SITE AND DEVELOPMENT PLAN STAFF REPORT: CIELO AMENITY TRACT AND ENTRY FEATURES

4/16/2019

PETITION NO.: 18-17SP

REQUEST: Construction of Improvements for an Amenity Tract, Including a Tot Lot and Dog Park, along with entry features and signage within the Cielo Subdivision (Part of The Milano Planned Unit Development).

Figure 2: Cielo Entrance Sign

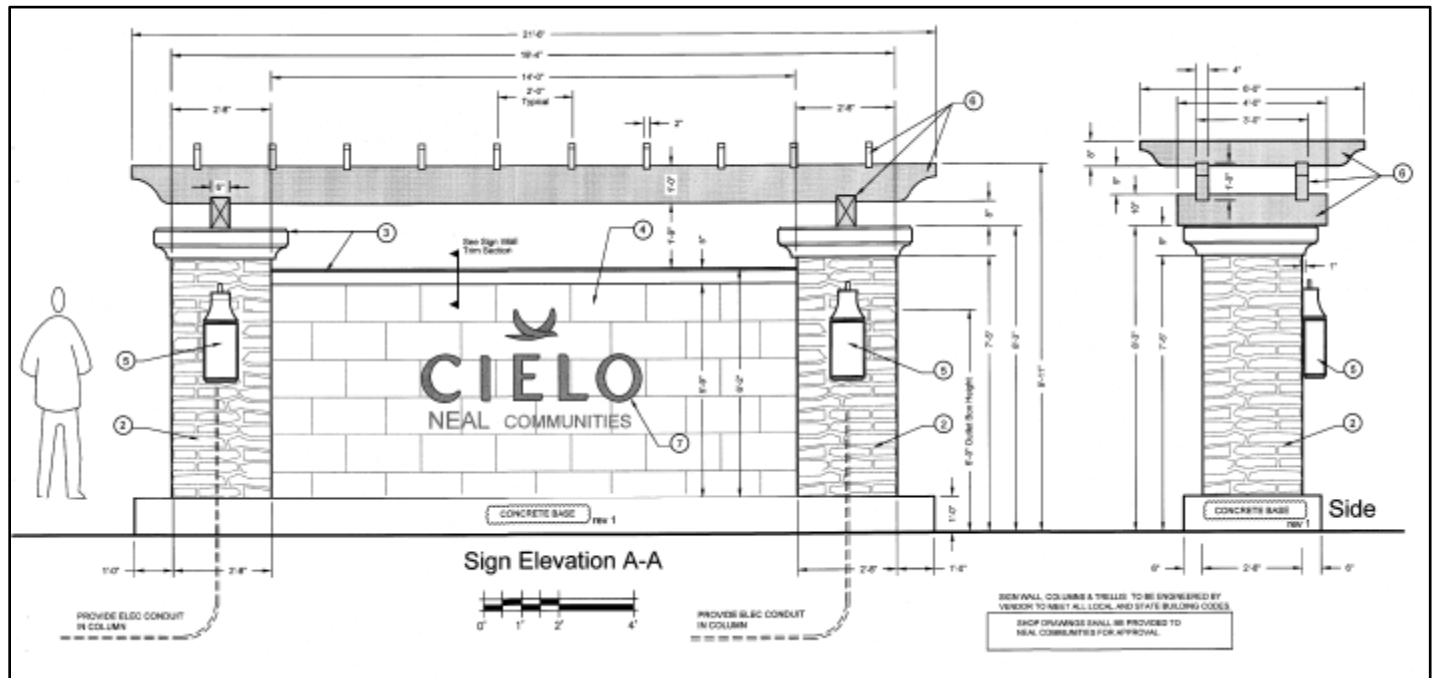
The Milano PUD does address entrance signs:

“One community identification, monument-style ground sign, not to exceed nine (9) feet in height and twenty (20) feet in width, on each side, or in the median and one side, of each vehicular access point off Jacaranda Boulevard, including access points at the intersections of Laurel Road and Jacaranda Boulevard, and Border Road and Jacaranda Boulevard.”

The signs proposed are typically interpreted as wall signs as they are not free standing and are an extension of the perimeter wall along Jacaranda Blvd.
